**STAFF RECOMMENDATION**

**1514 Paris Avenue**

**April 28, 2016**

**Application:** New construction—addition

Figure 2 (left) shows the right side of the house where the addition will be located, and Figure 3 (right) shows the left side of the house and the wide lot.

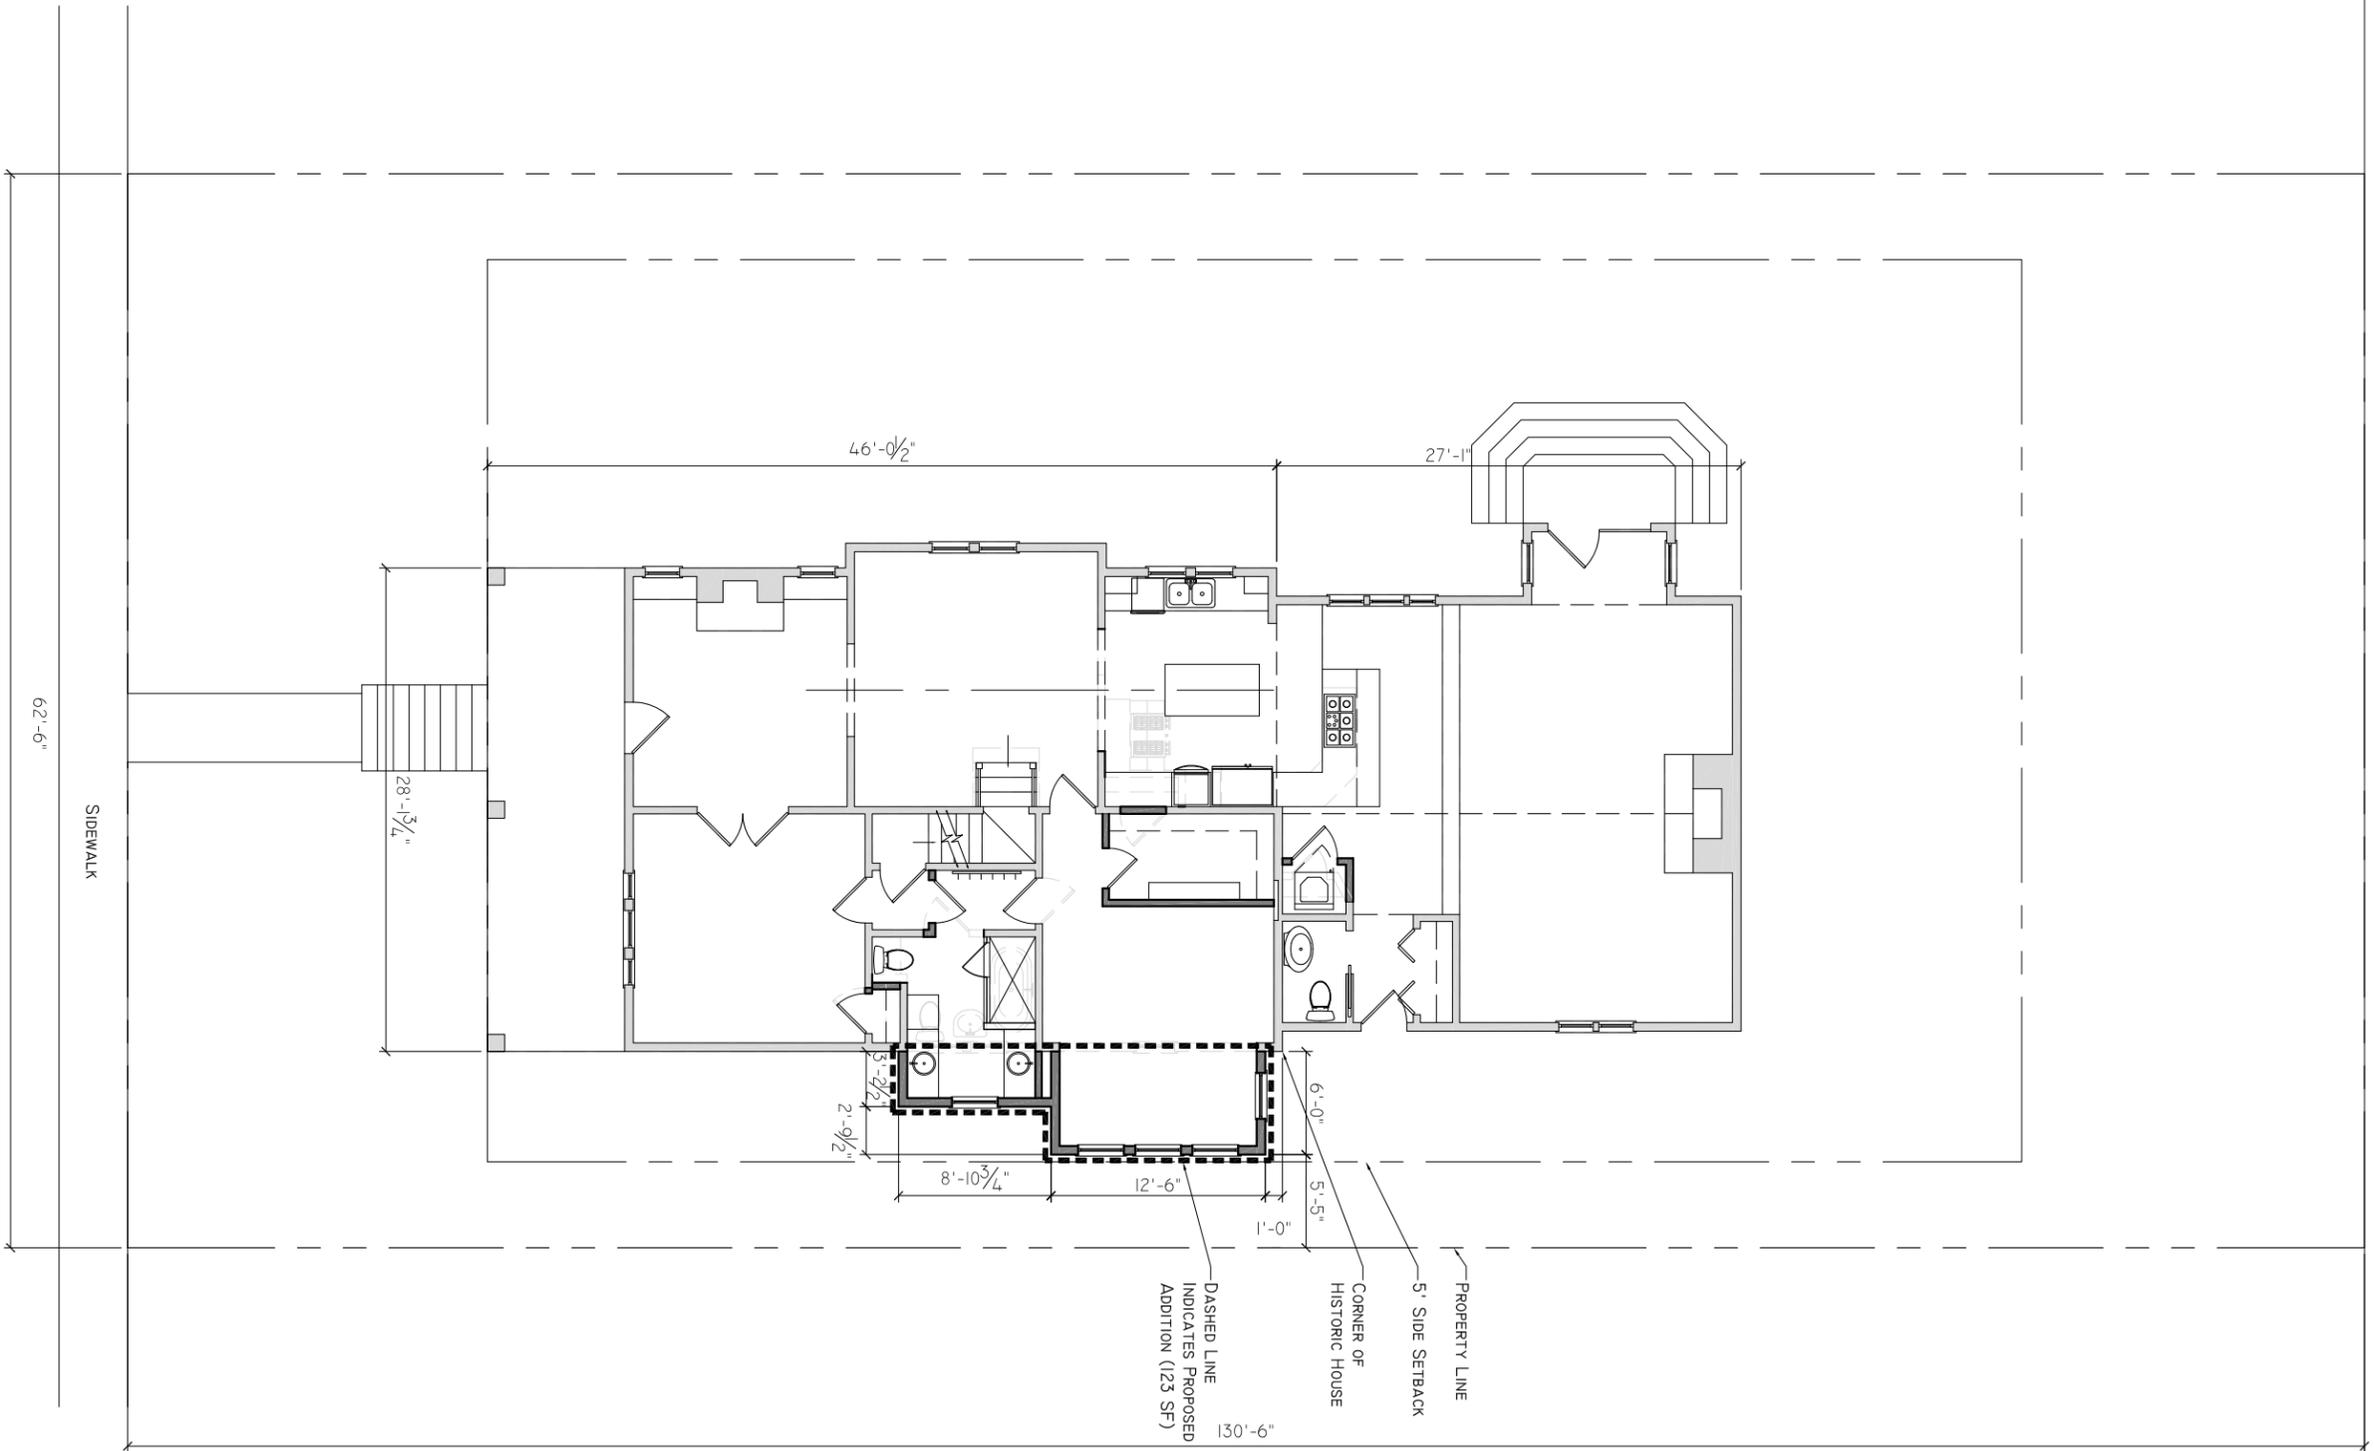
**Location & Removability:** The addition will be located on the right side of the house (Figure 2). Staff finds the proposed side addition to be appropriate for several reasons. The lot is unusually wide at over sixty-two feet (62'), and the design guidelines do permit side additions when lots are atypically wide and at least sixty-feet (60') wide (Figure 3). The addition will be located on the back half of the house and will be subordinate in size to the historic house. It will meet the required five foot (5') side setback. The addition will not interrupt any bays or decorative elements on the side façade. Staff finds that it could be removed in the future without affecting the historic integrity of the house. Staff finds that the side addition meets Section II.B.2.a and e. of the design guidelines.

A1.0

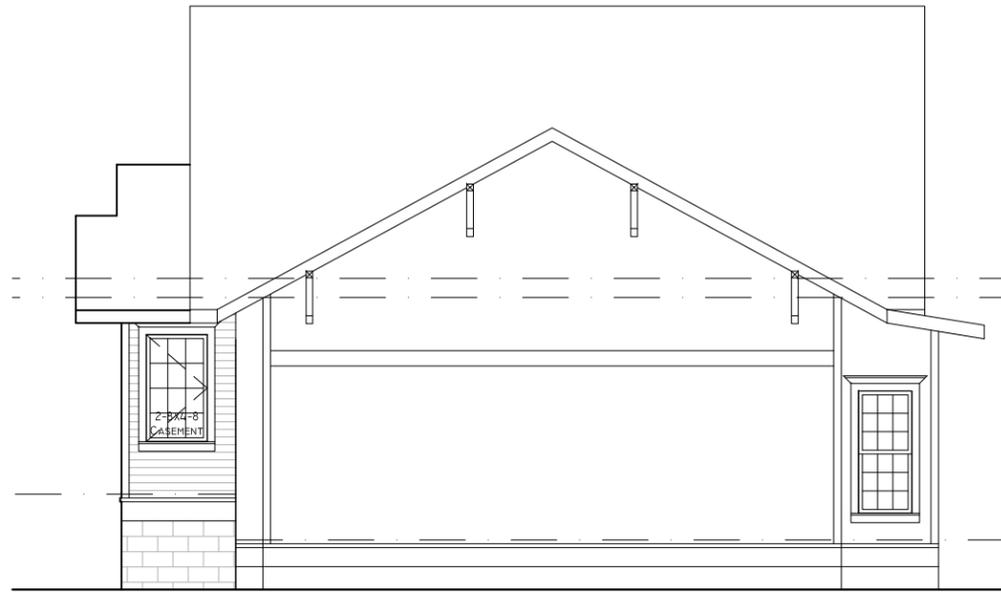
**Height & Scale:** The historic house is twenty-eight feet wide (28') at the front. The side addition will be a maximum of six feet (6') wide, which is less than half the width of the historic house. The foundation height will match the foundation height of the historic house. The height of the side addition will be between seven and nine feet (7' – 9') lower than that of the historic house. In total, the addition will add approximately one hundred and three square feet (103 sq. ft.) to the footprint of the house. Staff finds that the height and scale of the proposed addition is subordinate to the historic house and meets Sections II.B.1.a. and b. and II.B.2. of the design guidelines.

**Setback & Rhythm of Spacing:** The new addition will be approximately five feet, five inches (5'5") from the right side property line, thereby meeting the base zoning setbacks. Since the side addition is setback from the front façade and is only six feet (6') wide, it will not interrupt the established rhythm of spacing of houses along the street. Staff finds

A2.0

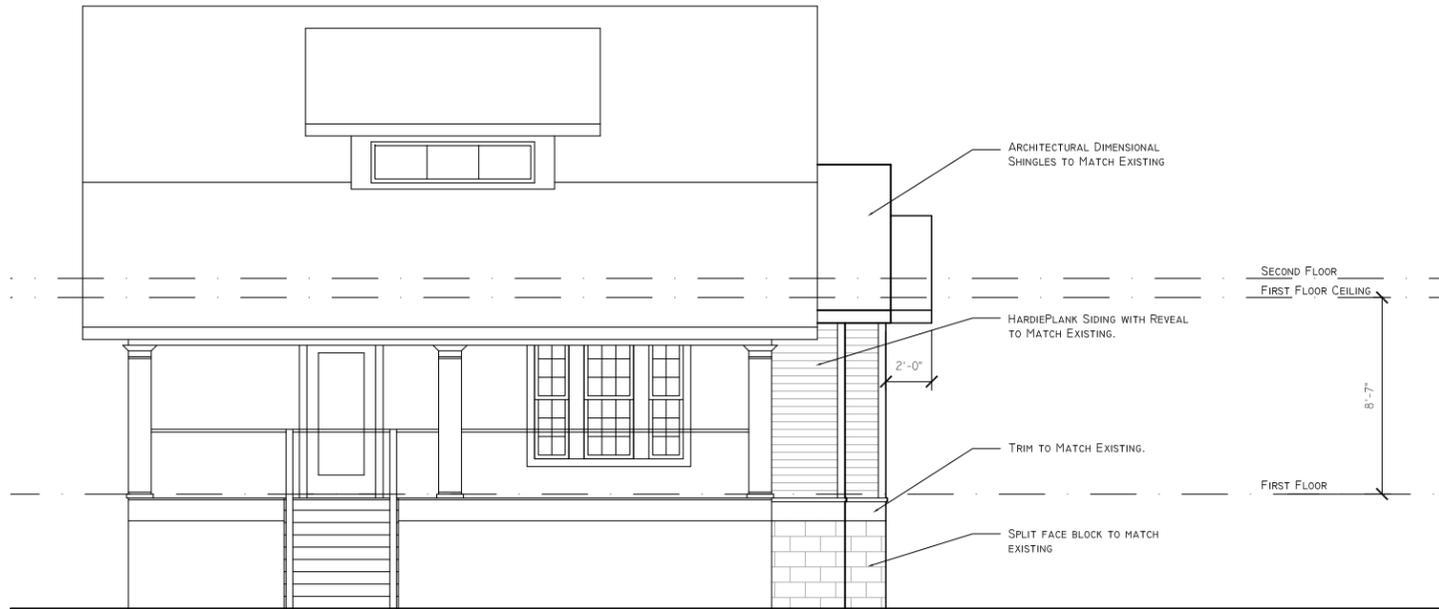
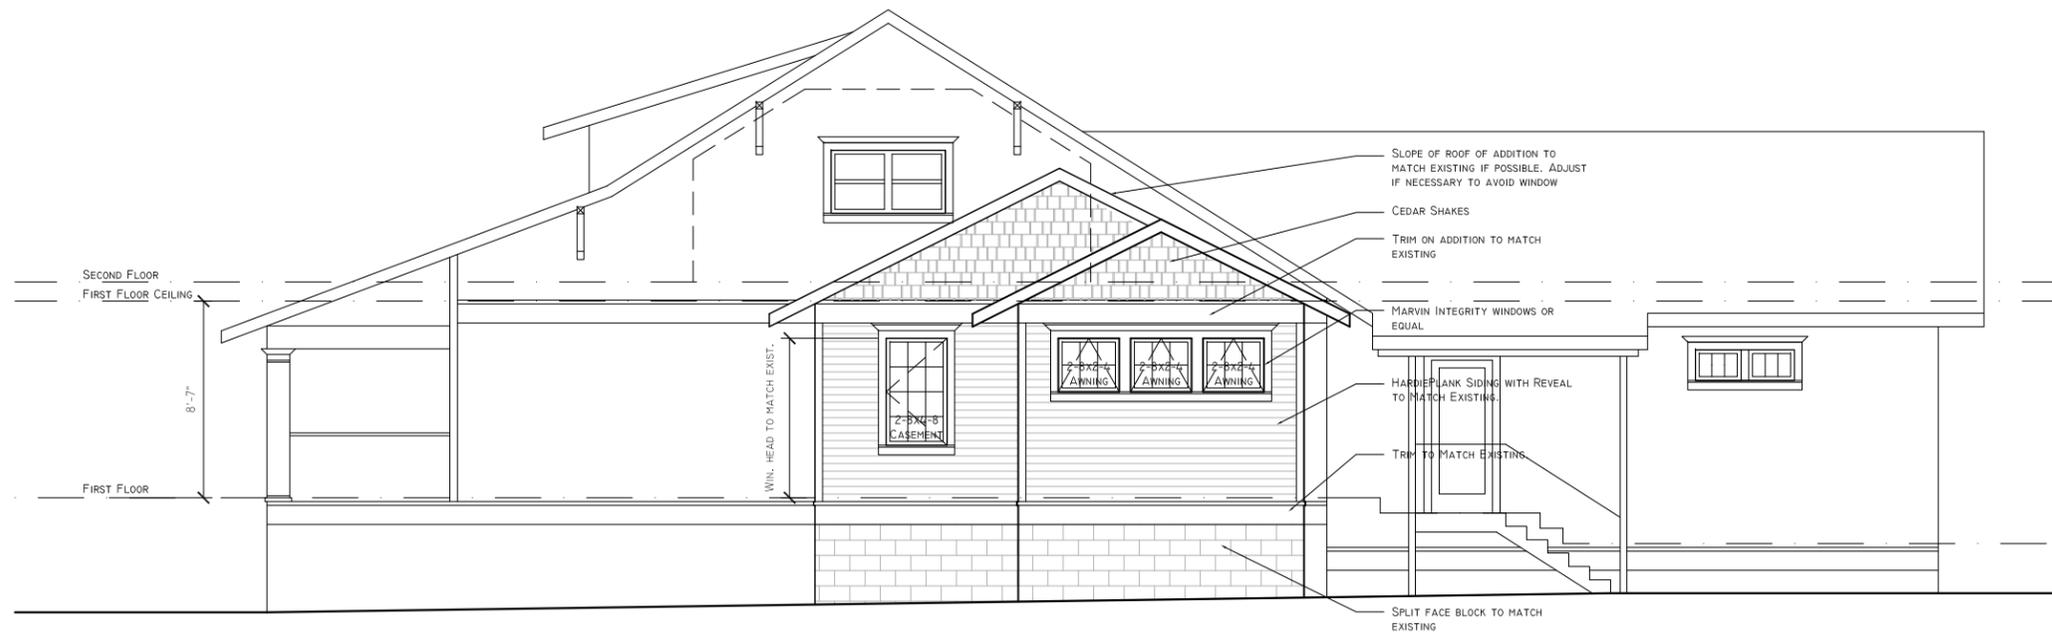
**Design:** The addition will be distinguished from the historic house with its separate roof forms and modern materials. At the same time, its materials, roof form, fenestration pattern, location, and design do not contrast greatly with the historic character of house. The addition is sufficiently subordinate to the historic house in height and scale. Staff finds that the proposed addition meets Sections II.B.2.a and f. of the design guidelines.

Materials: No major changes to the historic house's materials were indicated on the drawings. The addition will primarily be clad in smooth face cement fiberboard with a reveal to match that of the historic house. Cedar shakes will be used in the gable fields. The trim will be wood or cement fiberboard to match the historic house's trim. The foundation will be split face concrete block, and the roof will be architectural dimensional shingles in a color to match the existing roof. The windows will Marvin Integrity, which the Commission has approved in the past. Staff finds that the addition's materials meet Sections II.B.1.d. and II.B.2. of the design guidelines.

Roof form: The addition will have a side gable roof form, similar to that of the historic house. The side gable form will help to deemphasize the side addition. The pitch of the roof will approximate the pitch of the historic house's roof, but may vary slightly in order to not block the existing window in the gable field. Staff finds that the addition's roof form meets Sections II.B.1.e. and II.B.2. of the design guidelines.

Proportion and Rhythm of Openings: No changes to the window and door openings on the existing house were indicated on the plans. The windows on the proposed addition have appropriate proportions, and there are no large expanses of wall space without a window or door opening. Staff finds the project's proportion and rhythm of openings to meet Sections II.B.1.g. and II.B.2. of the design guidelines
